**Secretary, Parliamentary Standing Committee on Public Works
Parliament House, Hobart TAS 7000**

**Subject: Submission on the Kingston Bypass Duplication and Algona Road
Roundabout Upgrade**

Recommendations for the Overpass Design

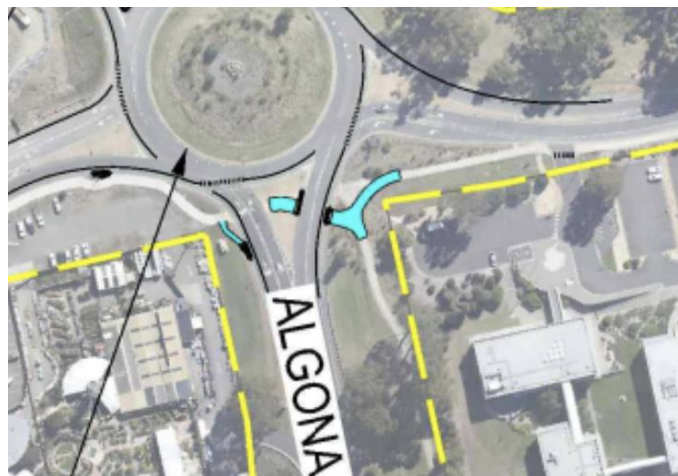
To effectively support active transport, the pedestrian overpass should be designed to comfortably accommodate both pedestrians and cyclists. Ensuring sufficient width is essential for safe and seamless movement.

The overpass must also feature a gradient that complies with accessibility standards, making it usable for individuals of all abilities. This consideration is vital to ensure inclusivity and promote regular use by the community.

Additionally, pathways leading to and from the overpass should be direct and well-aligned. Avoiding sharp or impractical turns will enhance usability and encourage more people to integrate active transport into their daily routines.

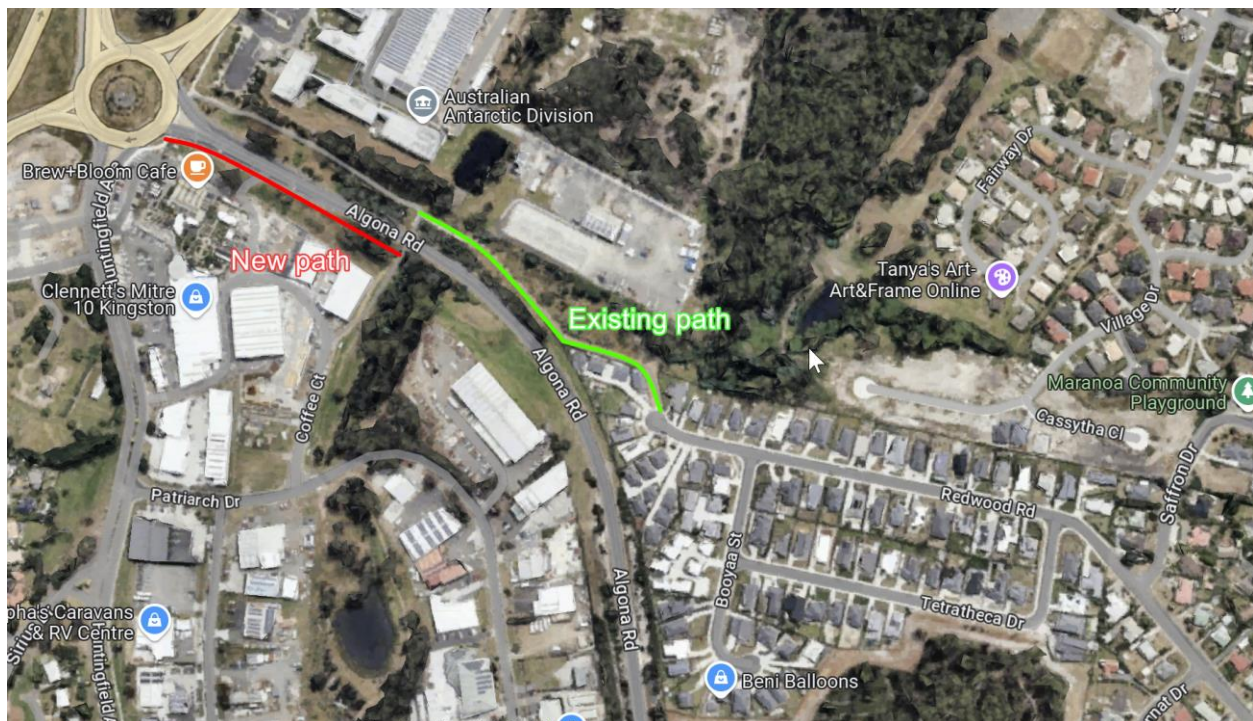
On the south side of the Algona Road crossing, a keep-clear zone or zebra crossing would be a cheap and effective way to make this part of the Algona Road crossing significantly easier for users of the path. I currently experience two lanes of traffic backed up here when crossing and find that vehicles are regularly stopped directly between the two sides of the path. This leads to a difficult to navigate, zig-zagging, crossing between momentarily stopped vehicles. Often, the drivers that can see me in the closest lane will wait for me to cross in front of them, but drivers in the next lane will not see and stop.

Designating space on the road for path users to cross may be a simple way to make this much safer and easier for path users.
